**NOTICE
OSHTEMO CHARTER TOWNSHIP
PLANNING COMMISSION**

**Regular Meeting
Thursday, March 14, 2019
6:00 p.m.
AGENDA**

1. Call to Order
2. Pledge of Allegiance
3. Approval of Agenda
4. Public Comment on Non-Agenda Items
5. Approval of Minutes: February 28, 2019
6. **SPECIAL USE REVIEW: Consumers Credit Union**
Bosch Architecture, representing Consumers Credit Union, is requesting special use and site plan approval for the redevelopment of their existing building located at 5018 West Main Street, to include drive through teller windows. Parcel No. 3905-13-280-062.
7. **SITE PLAN REVIEW: Metro Toyota**
Hurley & Stewart, representing Metro Leasing, LLC, is requesting site plan approval for the proposed automobile sales lot at 5924 Stadium Drive. Parcel No. 3905-25-305-031.
8. Old Business
9. Any Other Business
10. Planning Commissioner Comments
11. Adjournment

SITE DEVELOPMENT PLAN

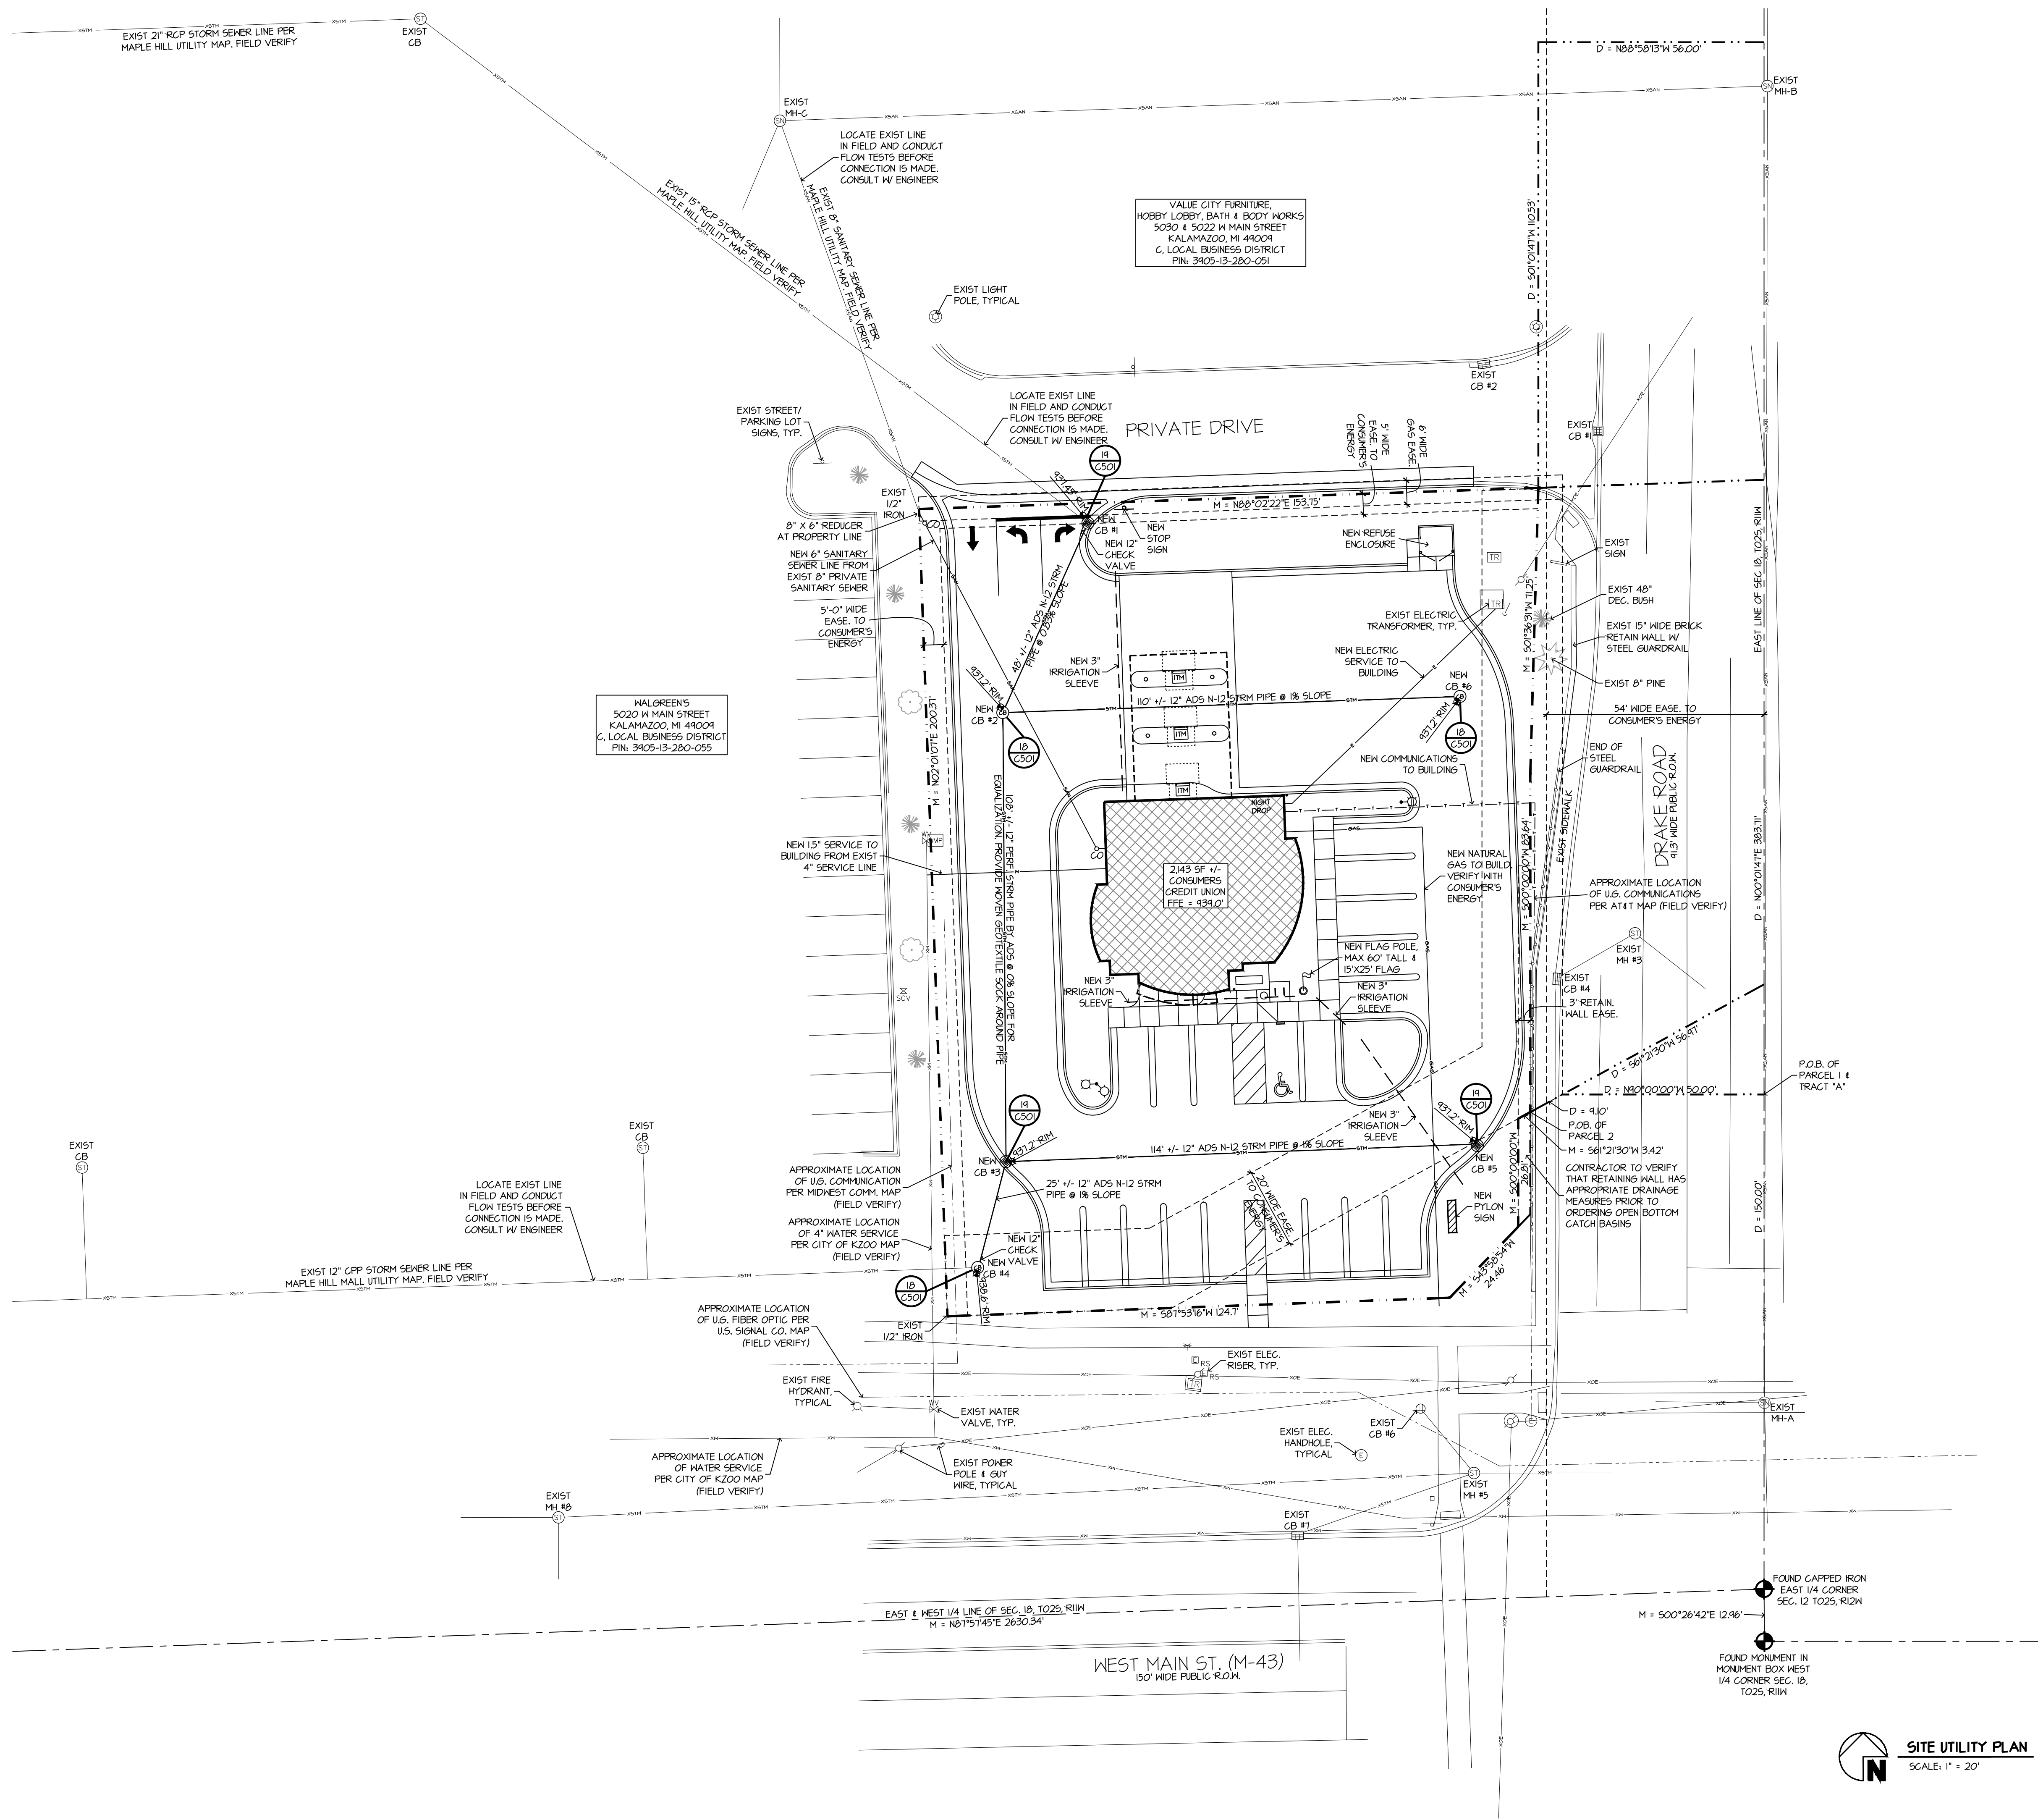
The proposed site design provides a smaller building footprint with the teller windows in the rear yard, allowing for better site circulation. In addition, landscape buffers have been added to the development and parking is now in the front and east side yard. A pedestrian connection is planned from the existing sidewalk along West Main Street to the site. This connection will need to be thoroughly detailed on the site plan, with appropriate striping through the parking lot.

Per the Ordinance requirements, concrete is planned for the accessible spaces near the front of the building. While the site plan provides a color distinction between those areas intended to be asphalt or concrete, there is no key on the site plan. While staff assumes the darker shaded areas are concrete, a key would confirm this hypothesis.

1. A key to indicate the difference between proposed surfaces on the site plan. This is to ensure that the accessible spaces are developed as concrete per Ordinance requirements.

1. A revised site plan be provided before the issuance of a building permit with the following:
 - a. A key to indicate the difference between proposed surfaces.

SITE GRADING PLAN

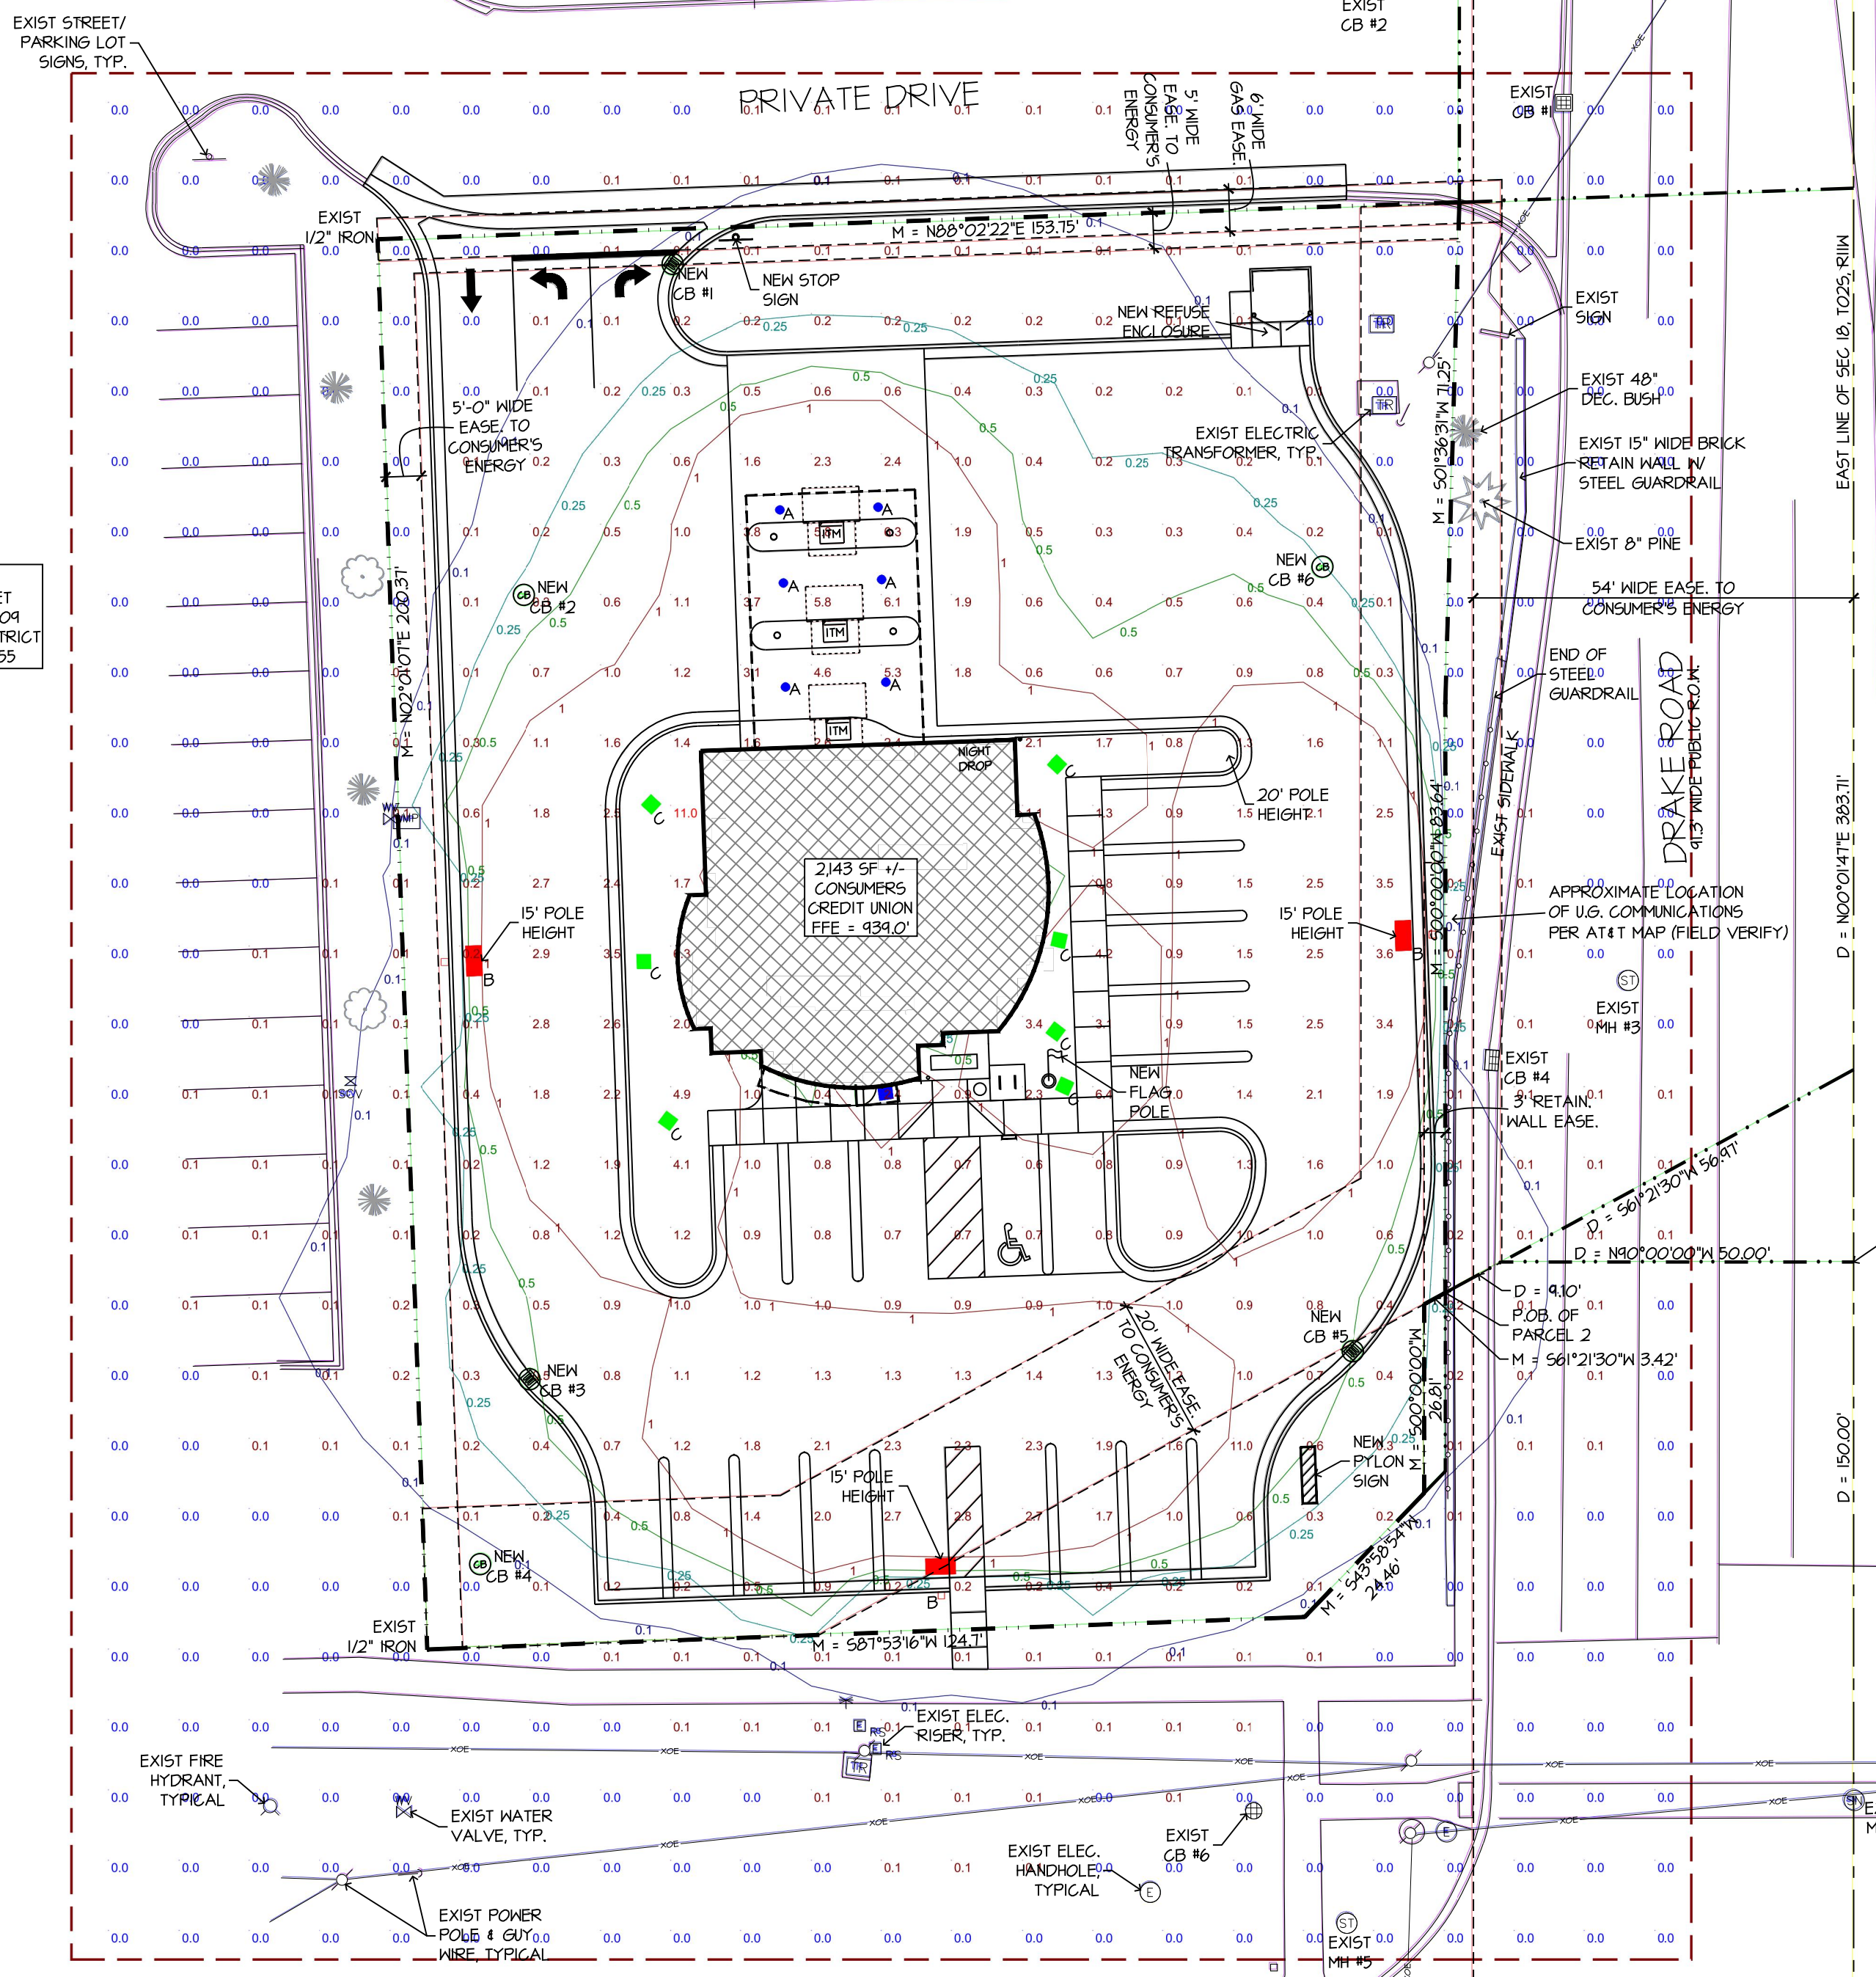
No concerns. However, the Township Engineer would like to see spotting maps and/or locational information will be collected and captured on as-built (red-lined) record plans as the public utility connections (water and wastewater) are reconstructed.

5. As the public utility connections (water and wastewater) are reconstructed, spotting maps and/or locational information will be collected and captured on as-built (red-lined) record plans to be submitted to the Township prior to a certificate of occupancy.
